City of Arts & Innovation

Cultural Heritage Board Certificate of Appropriateness Staff Report

I. CASE NUMBER(S): P13-0084

- 1) Proposal:** Proposed rehabilitation of the Riverside Main Library to add an exterior entry lobby projection, install windows behind existing exterior concrete screens and related minor improvements, located just south of the Mission Inn in the Downtown Specific Plan Raincross District. The Library is within the Mission Inn Historic District and Seventh Street Historic District, and has been determined eligible for the California Register of Historical Resources and as a City Landmark.
- 2) Location:** 3581 Mission Inn Avenue
- 3) Applicant:** Tonya Kennon, Library Director
City of Riverside Library Department
3581 Mission Inn Avenue
Riverside, CA 92502
951-826-5213
- 4) Case Planner:** Teri Delcamp, Historic Preservation Senior Planner
(951) 826-2117
tdelcamp@riversideca.gov

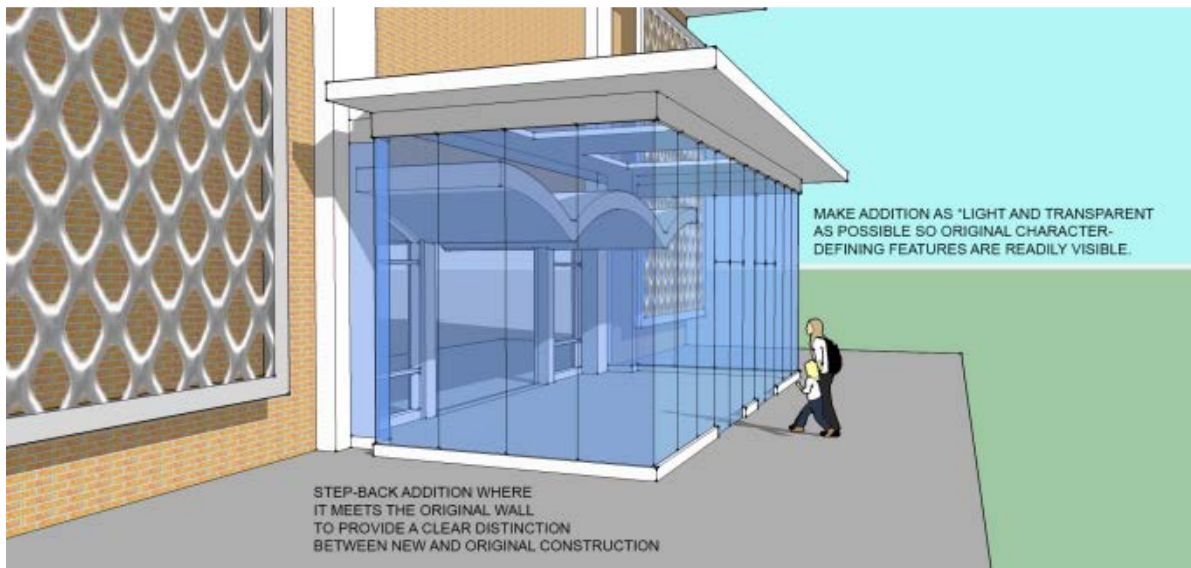
This option proposes retaining the sculptural entrance canopy and enclosing it within a square entrance bay addition. The entrance bay addition would measure 32'4" feet across and 15' deep, with a canopy measuring 39'4" by 24'4". The bay addition would be designed to be reversible (in conformance with *Secretary's Standards* #10). Unlike Option 5a, Option 5b calls for a thin roof section with a flat ceiling/soffit designed to be visually subordinate to the existing curved plate canopy.

Additionally, the plan calls for altering the smooth wall expanse of the second-story of the façade by adding two doors above the addition, in order to provide access to a roof deck. This deck, highly visible from the exterior of the building, would be fronted by a railing high enough to conform to the applicable Building Code (typically 42-inches).

Option 5b could potentially meet the *Secretary's Standards* with the following conditions and modifications [refer to Appendix A for the design sketches with shading for emphasis]:

OPTION 5b ELEVATION
SCALE 1/16" = 1'-0"

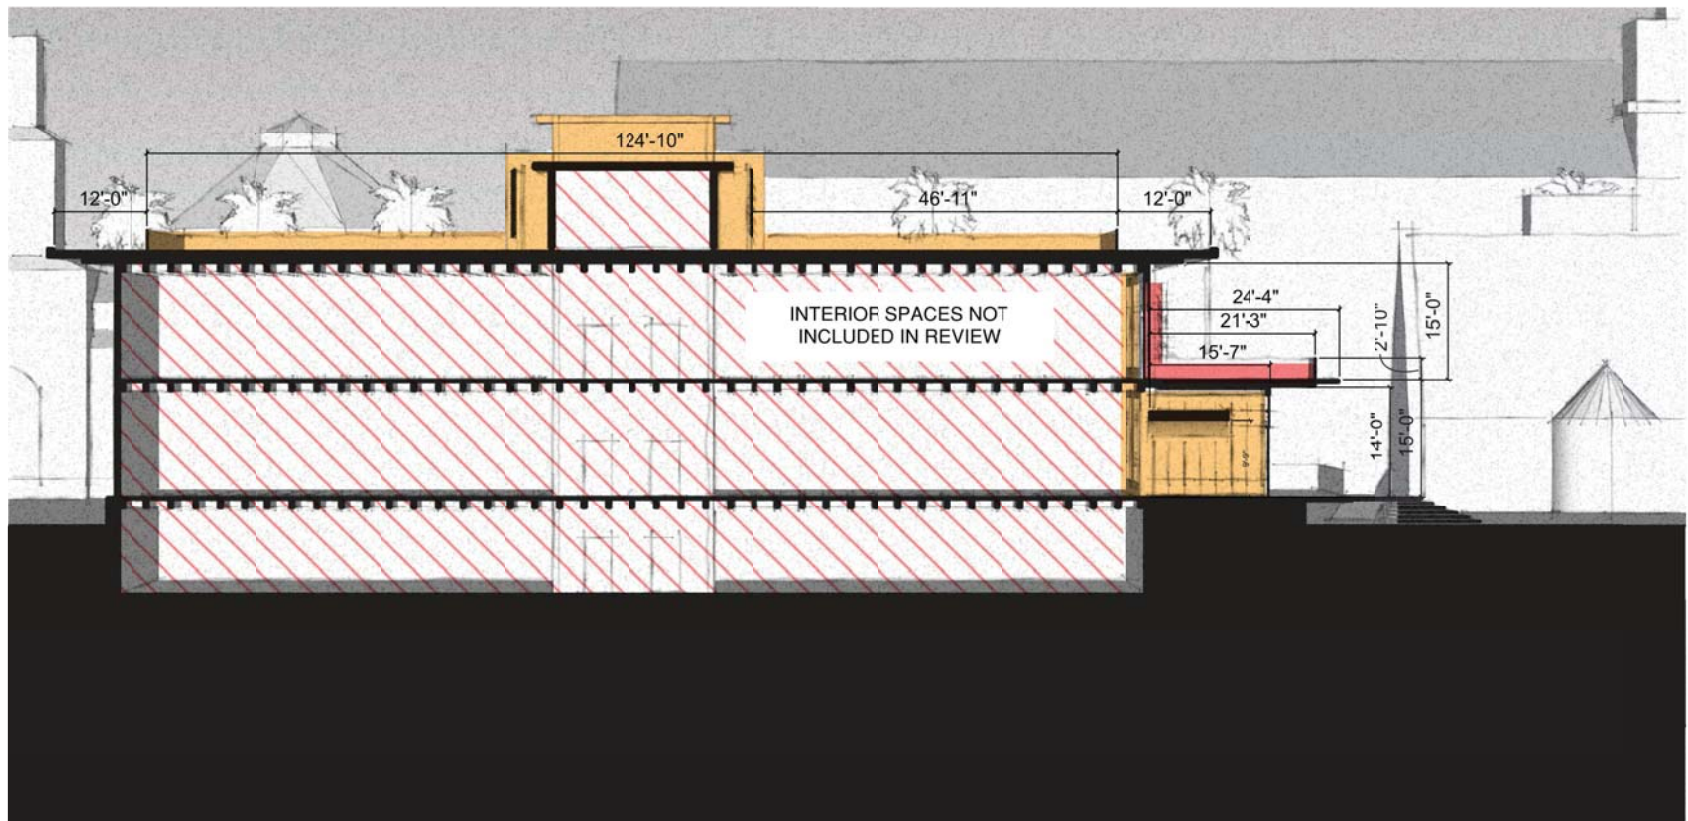
1. The **proposed exterior doors for from the second floor to the deck above the addition need to be eliminated from the project** in order to conform with the *Secretary's Standards* Nos. 1, 2, and 9 (see above). The addition of upper-façade doors would represent more than a "minimal change" to distinctive materials (smooth/planar brick wall surfaces) and features (the façade's overall design configuration). The addition of upper-façade doors and a thickened profile for the proposed entrance bay through the addition of a roof deck and railing will alter the building's principal character-defining feature, the distinctive entrance design and materials. These changes constitute **more than a "minimal change" to the distinctive features and spatial relationships of the building**.

2. Step-back the sidewalls and roof projection of the new entry addition at the connection to the original wall plane to provide a clear differentiation between new and original construction. [Refer to Sketch 1].

The design should not obscure the visibility of the sculptural entrance canopy. In addition, an effort should be made to provide skylights or laylights that will allow for natural illumination, thereby increasing visibility of the original entrance.

- ELEMENTS THAT DO NOT CONFORM TO THE *SECRETARY'S STANDARDS*. IT IS RECOMMENDED THESE ITEMS BE REMOVED FROM THE PROJECT.
- ELEMENTS THAT CAN CONFORM WITH THE *SECRETARY'S STANDARDS* WITH CERTAIN MODIFICATIONS AND CONDITIONS [REFER TO MEMORANDUM].
- ADDITIONAL INFORMATION REQUIRED TO EVALUATE CONFORMANCE WITH THE *SECRETARY'S STANDARDS*.
